# UNITED STATES PATENT AND TRADEMARK OFFICE

APPLICATION NO.	FILING DATE	FIRST NAMED INVENTOR	ATTORNEY DOCKET NO.	CONFIRMATION NO.
10/699,208	10/31/2003	Leonard Stevens	64104-00002USPT	2784

<b>Office Action Summary</b>	<b>Application No.</b> 10/699,208	<b>Applicant(s)</b> STEVENS ET AL	
	<b>Examiner</b> Michael G. Mendoza	<b>Art Unit</b> 3731

## **DETAILED ACTION**

**Fig. 12**

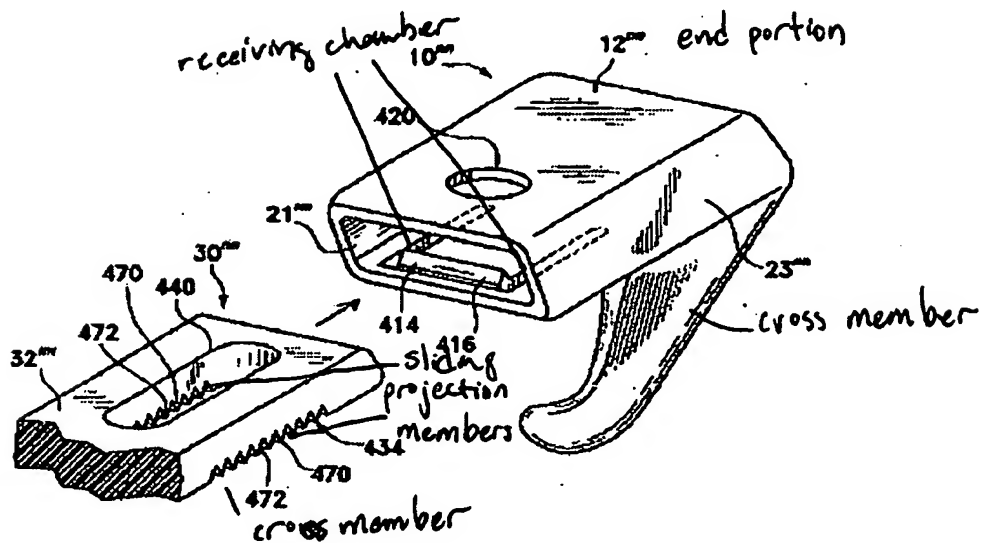
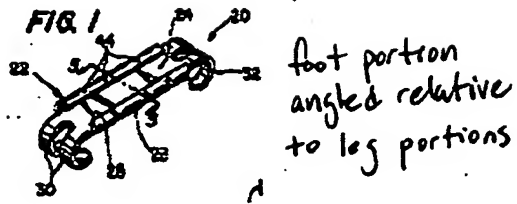
12. Regarding claims 1 and 2, Hogendijk et al. disclose in Fig. 12 the device comprising impermanently joined sliding (10''') and receiving (30''') attachment structures. Each structure has a cross member (see Fig. 12 inserted below) and an end portion (12 '''). Fig. 12 is a structurally analogous embodiment of Fig. 1 (col. 3, lines 65-67), which more clearly shows the receiving attachment structure's end portion (32) and the plurality of sternum engagement surfaces (bottom of 17 and 72, 20, 22, 40, 42). Hogendijk et al., however, disclose in Fig. 1 only one foot (20, 40) and leg (16, 36) portion on each structure and not a plurality of foot and leg portions on each structure. Crossett et al. disclose in Fig. 4 a plurality of foot (36, 38) and leg (30, 32) portions on each structure. This additional structure is simply a duplication of parts, and it is well known to add another leg or foot portion to enhance the securement of the sternum clamp to the sternum. It would have been obvious to one having ordinary skill in the art at the time of the invention to add another leg and foot portion to each structure to strengthen attachment of the device to the sternum.

13. Regarding claim 2, Hogendijk et al. disclose in Fig. 12 the receiving structure (30''') comprising a resiliently tensioned locking member with angularly disposed teeth

like structures (47) outwardly positioned at first (bottom 470) and second (top 470) ends of the locking member. Hogendijk et al. further disclose a securing aperture (440) substantially centered there between.

20. Regarding claim 12, Hogendijk et al. disclose in Fig. 12 a method comprising positioning sliding (30''') and receiving (10''') attachment structures about a respective sternal half (col. 6, lines 59-64). The opposed sliding and receiving attachment structures can be aligned for insertion of sliding structure projection members (see Fig. 12 below) into receiving chambers (located on each side of 416) of the receiving attachment structure. Fig 1, of which Fig. 12 is a structurally analogous embodiment

**Fig. 9**

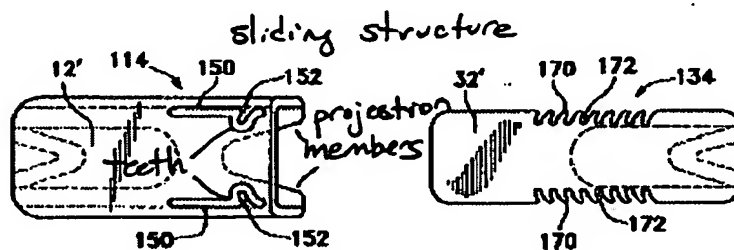
14. Regarding claims 1, 3-10, 12, and 15, Hogendijk et al. disclose in Fig. 9 the device comprising impermanently joined sliding (114) and receiving (134) attachment structures. Each structure has a cross member (12', 32') and an end portion (the left and right ends of 12', 32'). Fig. 1 of which Fig. 9 is a structurally analogous embodiment (col. 3, lines 54-56), shows the plurality of sternum engagement surfaces (bottom of 17 and 72, 20, 22, 40, 42). Hogendijk et al., however, disclose in Fig. 1 only one angled foot (20, 40, the foot is angle with respect to the leg) and leg (16, 36) portion on each structure and not a plurality of foot and leg portions on each structure. Crossett et al. disclose in Fig. 4 a plurality of foot (36, 38) and leg (30, 32) portions on each structure. This additional structure is simply a duplication of parts, and it is well known to add another leg or foot portion to enhance the securement of the sternum clamp to the sternum. It would have been obvious to one having ordinary skill in the art at the time of the invention to add another leg and foot portion to each structure to strengthen attachment of the device to the sternum.

15. Regarding claim 3, Hogendijk et al. disclose in Fig. 9 the sliding structure (114) comprising a plurality of projection members (see Fig. 9 below) with angularly disposed teeth like structures (152) inwardly positioned on each innermost surface of each projection member.

17. Regarding claim 7, Hogendijk et al. disclose in Fig. 9 the receiving attachment structure (134) comprising a securing means (170) to facilitate the operative securing of the structures to one another. The teeth (170) of one structure engage the teeth (152) of the other structure to secure the structures to one another.

22. Regarding claims 15 and 17, Hogendijk et al. disclose in Fig. 9 the device wherein the securing means (170) may be removed to facilitate immediate device disengagement.
